Transitioning from the CS4382 to the CS4382A or CS4385

This application note describes how to transition easily to the CS4385 or CS4382A from an existing design which uses the CS4382. The CS4382A was designed to give a simple upgrade path from the CS4382 whereas the CS4385 adds some additional features. Please refer to the CS4382A and CS4385 data sheets for supplemental information and specifications concerning operation of the device. A brief comparison between the product families is shown in Table 1.

Figure 1. CS4382 pinout

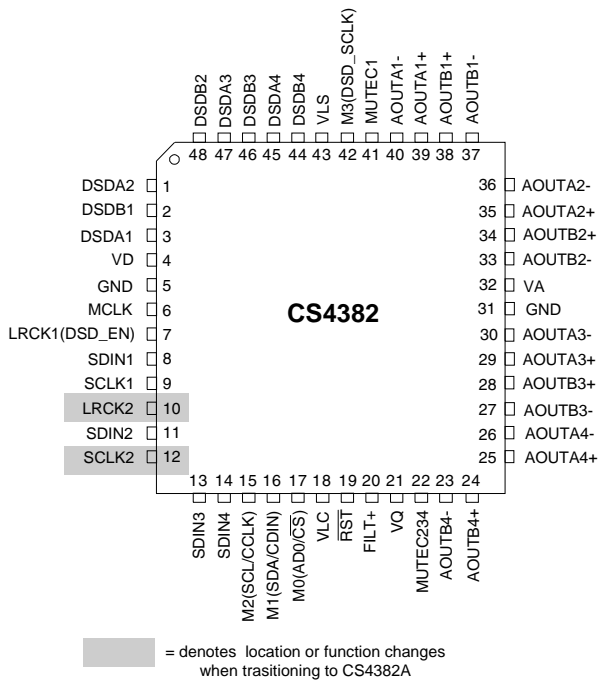
Location or function changes as denoted in Figure 1 are as follows:

- The CS4385 does not support the simultaneous synchronous sample rate function of the CS4382. Pins 10 and 12 are now Test inputs.

Figure 2. CS4382A pinout

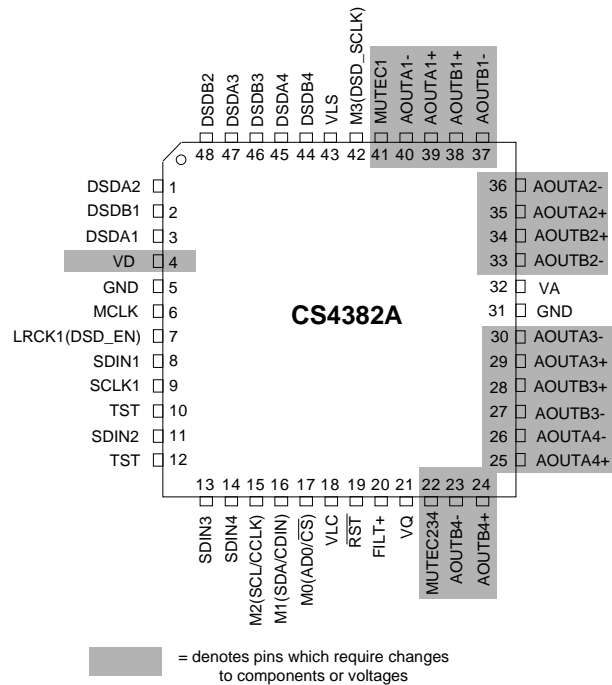
Pins which require changes to external components or voltages as denoted in Figure 2 are as follows:

- Pin 4 (VD) requires 2.5 V for recommended operation. The CS4382 used either 3.3 V or 5 V, which, if left unchanged, would damage the CS4382A.
- Pin 22 (MUTEC234) and pin 41 (MUTEC1) require an additional pull-up or down in order to mute during reset. While reset is asserted these pins are high impedance and will not drive the mute circuitry. It is recommended that the pull-up/down resistance properly biases the off-chip mute circuit into muting.

- Pins 23 - 30, 33 - 40 (AOUTs) have a new recommended filter circuit. This filter uses the same filter topology as the CS4382. The component values have been changed to account for the extra output level from the CS4382A and still provide 2 V_{rms} on the output. A general optimization was also made in order to reduce the thermal noise contribution of the resistances (using smaller resistances where possible). Please refer to the CS4382A datasheet for details on the new recommended filter.

Figure 3. CS4382 pinout

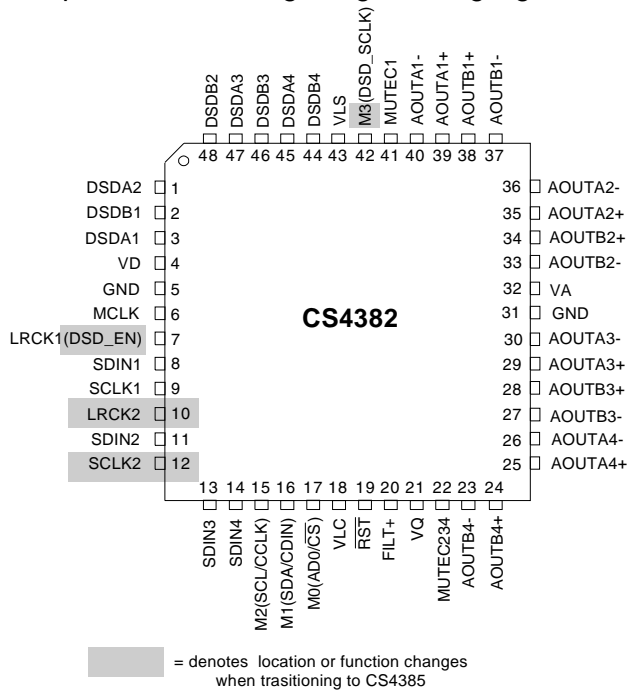
Location or function changes as denoted in Figure 3 are as follows:

- Pin 7 is no longer DSD_EN in hardware mode. In order to enter DSD mode on the CS4385 you must either set the M4 and M3 pins accordingly or use SPI™ or I²C configuration.
- The CS4385 does not support the simultaneous synchronous sample rate function of the CS4382. Pins 10 and 12 are now dedicated for stand-alone configuration (voltage input on these pins are still referenced to VLS).
- Pin 42 no longer functions as M3 in stand-alone PCM modes. It is now a dedicated DSD_SCLK pin.

Figure 4. CS4385 pinout

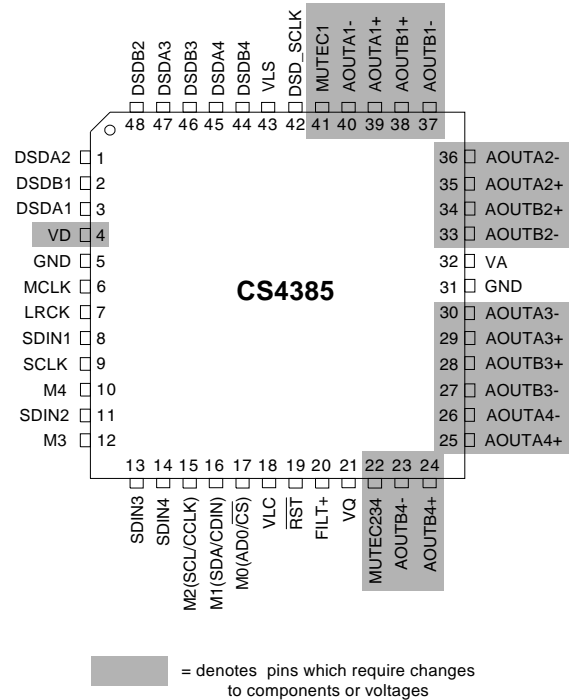
Pins which require changes to external components or voltages as denoted in Figure 4 are as follows:

- Pin 4 (VD) requires 2.5 V for recommended operation. The CS4382 used either 3.3 V or 5 V, which, if left unchanged, would damage the CS4385.
- Pin 22 (MUTEC234) and pin 41 (MUTEC1) require an additional pull-up or down in order to indicate the desired direction of mute polarity. While reset is asserted these pins are high impedance and will not drive the mute circuitry. It is recommended that the pull-up/down resistance properly biases the off-chip mute circuit into muting.

- Pins 23 - 30, 33 - 40 (AOUTs) have a new recommended filter circuit. This filter uses the same filter topology as the CS4382. The component values have been changed to account for the extra output level from the CS4385 and still provide 2 V_{rms} on the output. A general optimization was also made in order to reduce the thermal noise contribution of the resistances (using smaller resistances where possible). Please refer to the CS4385 datasheet for details on the new recommended filter.
